RE: CHANGE APPLICATION TO A DEVELOPMENT PERMIT FOR A MATERIAL CHANGE OF USE AND BUILDING WORK FOR A MULTIPLE DWELLING

33 OXLADE DRIVE, NEW FARM QLD 4005 AND FORMALLY DESCRIBED AS COMMON PROPERTY (LOT 0) AND LOTS 1-16 ON BUP1982

RESPONSE TO COUNCIL FURTHER ADVICE (APPLICATION REFERENCE: A007025570)

Figure 1: Plans highlighting the increased boundary setbacks across all levels (in green)

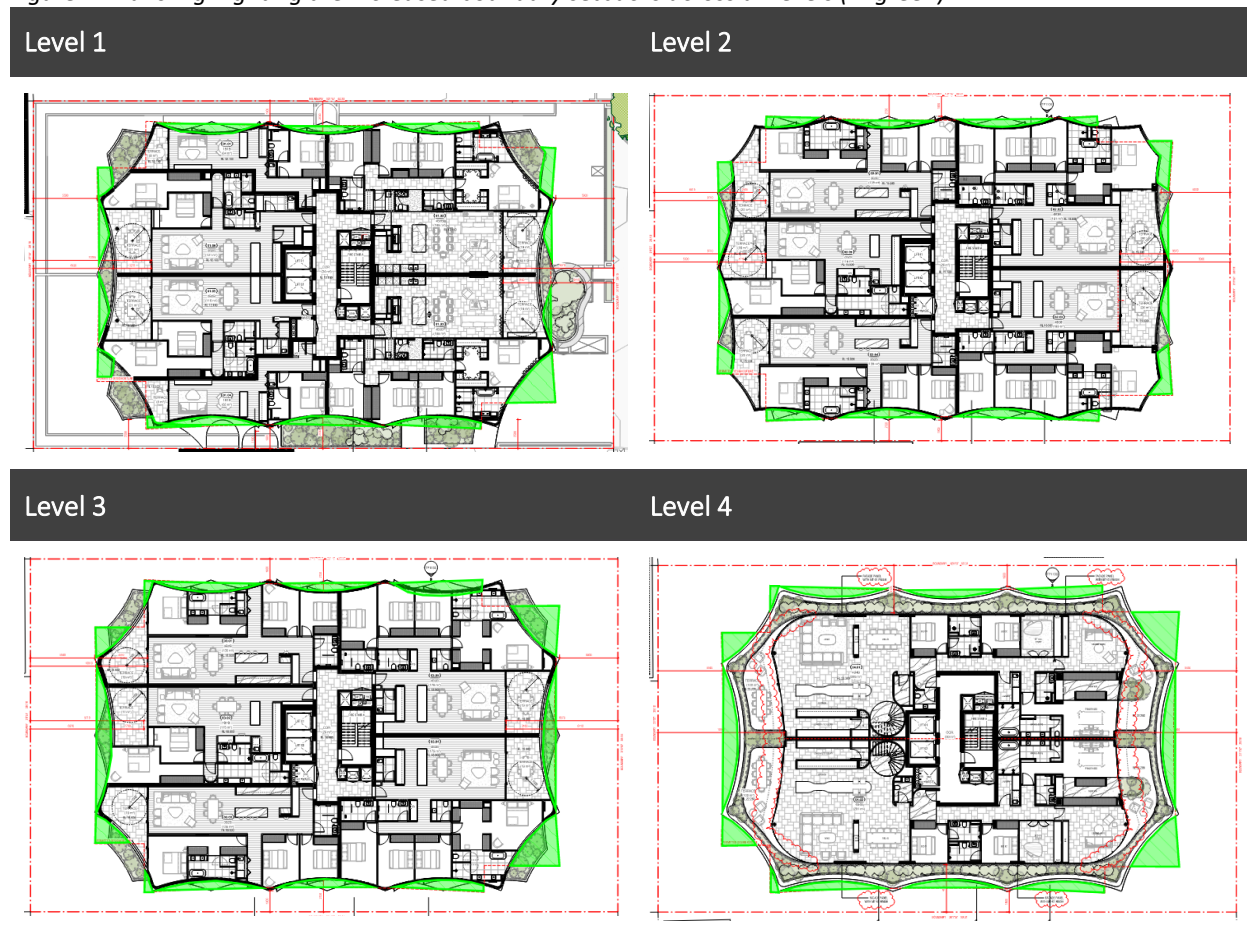
(1) Although the development remains five storeys, the reduced wall setbacks on all elevations increase the building's perceived bulk and scale. This outcome is likely to result in increased adverse amenity impacts on adjoining properties, contrary to AO7.1 of the Multiple dwelling code.

(a) Provide amended plans that maintains approved side boundary setbacks to walls and balcony across all levels.

The amended plans maintain or improve the approved building setbacks across the relevant elevations and levels. The revised design does not increase the extent of built form toward adjoining boundaries in a manner that would result in additional adverse amenity impacts.

For clarity, the amended building edge incorporates a curved recess in plan. The point of maximum setback occurs at the apex of this recess, with the broader building edge providing increased articulation and separation when compared with the approved building envelope. The increased setback areas are identified in green in **Figure 1** below.

The amended design therefore does not represent a reduction in the approved setback outcome. Rather, it redistributes and reduces built form in a manner that improves building articulation, reduces perceived bulk and maintains an appropriate relationship with adjoining properties.

Figure 2: Revised boundary fencing and landscape planter with 50% opacity

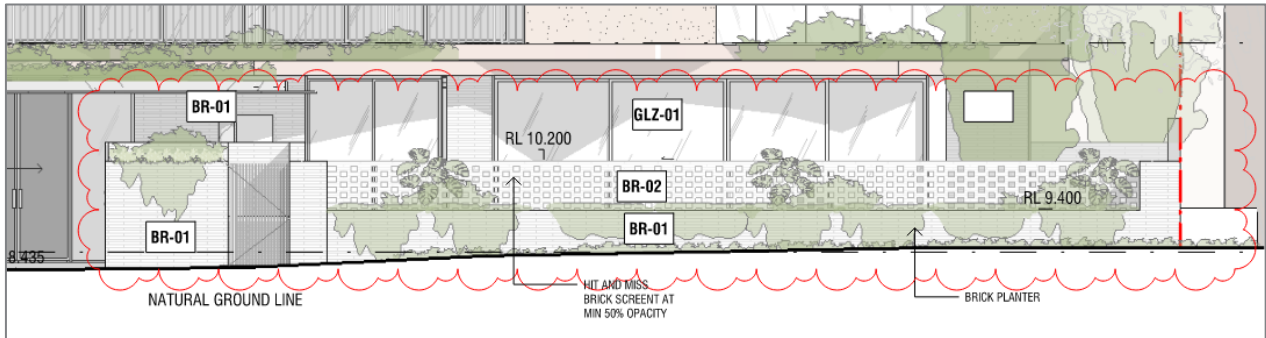
- (2) *It is understood that units are maintained on ground floor and a 1.5m to 1.7m solid brick wall is proposed at the front boundary which is seen to be a regression in terms of activation and facilitation of casual surveillance in accordance with AO37.1/PO37 of the Multiple dwelling code.*

(a) *Provide amended plans and elevations to reduce brick wall to maximum 1.2m height or minimum 50% hit and miss with the current proposed fence height.*

The plans have been amended to improve the ground floor and streetscape interface. The revised frontage treatment reduces the extent and apparent height of solid walling, extends the front landscape planter and incorporates hit and miss brickwork to achieve a more open and visually recessive edge to the street.

The front boundary treatment now comprises a lower front wall of approximately 600mm to 800mm, with planting and a setback hit and miss brick screen behind. The hit and miss component is approximately 700mm high and is designed to provide visual permeability, casual surveillance and material variation while maintaining privacy for the ground floor units.

This arrangement is consistent with the intent of AO37.1 and AO37.2 of the Multiple dwelling code because it avoids a long, blank, solid wall to the street and provides indentations, landscape planting, material variation and visual interest to soften the frontage. On this basis, the amended design provides an improved streetscape activation outcome and appropriately balances privacy, overlooking and casual surveillance.

Figure 3: Detail Window and Façade Sections

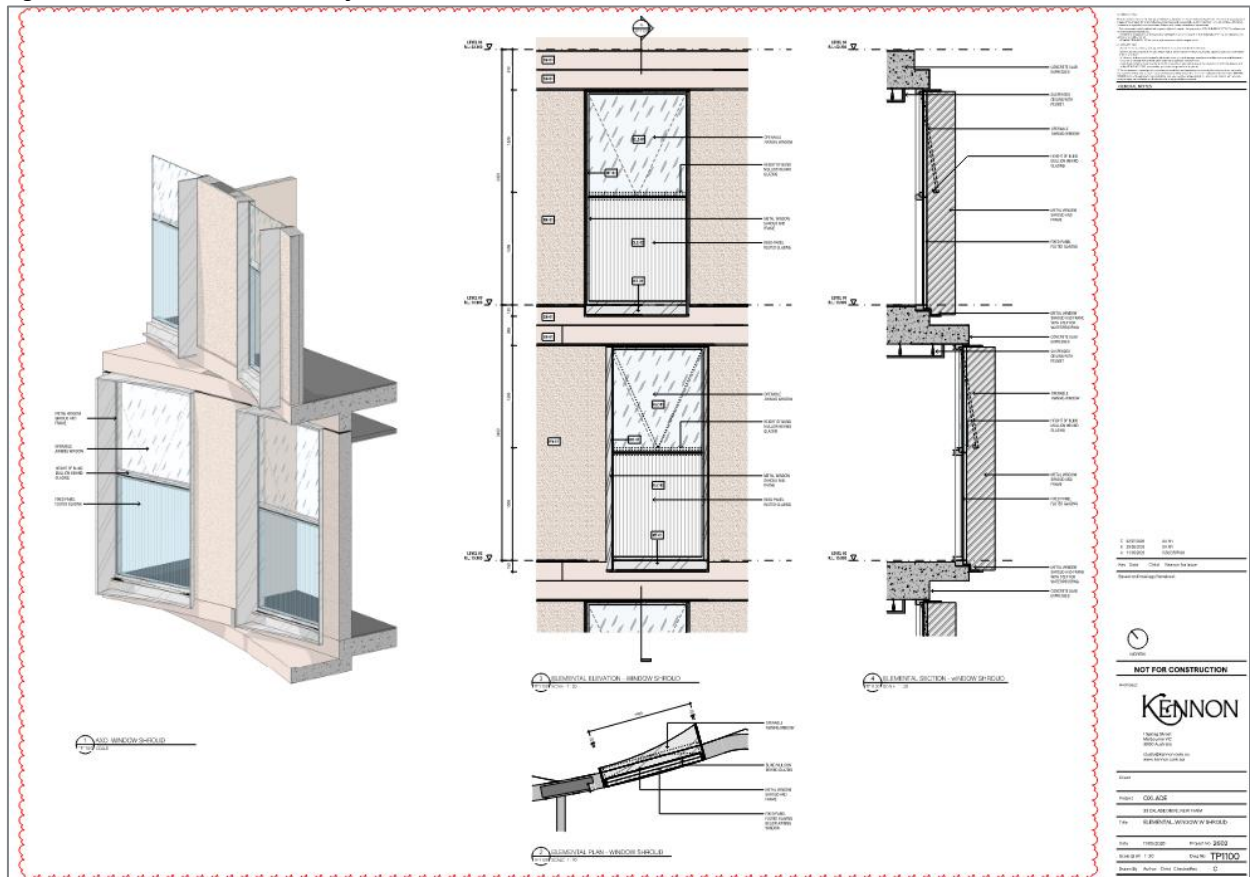
- (3) The architectural report presents conflicting information regarding window treatments to habitable rooms. While it is understood that the approved scheme provided textured glass up to 1500AFFL to maintain visual privacy, elevations on the proposed scheme indicates clear glass up to 1500AFFL with semi reflective glass above.*

- (a) Clarify window treatment and provide a detail section through a typical window box to illustrate material treatment to the shading device*
- (b) Clarify whether upper portion of window is operable to ensure natural ventilation is maintained to habitable rooms as per the approved scheme*

- (4) It is understood that façade treatment to Level 4 has been updated to large expanses of clear fixed glazing. This is an unsupportable outcome and is considered an inappropriate response to Brisbane's subtropical character and climate as, coupled with insufficient shading elements to manage solar exposure, units on this level are at risk of heavily relying on mechanical ventilation to maintain comfort.*

- (a) Provide amended drawings to illustrate a more appropriate façade treatment to Units 04.01 and 04.02 to balance solid and transparent elements with consideration of solar exposure and controllable measures. Refer to Subtropical Building Design Planning Scheme Policy.*

The amended architectural drawings clarify the proposed window and façade treatment to habitable rooms. The window detail confirms that the façade incorporates a layered window shroud treatment, comprising projecting side fins, recessed glazing, sill elements and operable window components. This provides depth, shading and articulation to the façade rather than presenting as a flat glazed elevation.

In relation to Item 3, the amended drawings clarify that the lower portion of the relevant window openings includes privacy screening / obscure treatment to assist in maintaining visual privacy, generally consistent with the intent of the approved scheme. The upper window portions remain glazed and include operable awning window components, ensuring that habitable rooms continue to receive natural ventilation. The submitted detail also provides a typical section through the window shroud, confirming the material treatment and depth of the external shading elements.

In relation to Item 4, the Level 4 façade treatment has been amended to provide a more balanced composition of solid and transparent elements. The revised window shroud detail reduces the appearance of large expanses of clear fixed glazing by introducing vertical solid side elements, recessed glazing, operable window portions and external shading. This creates a more articulated and climatically responsive façade outcome.
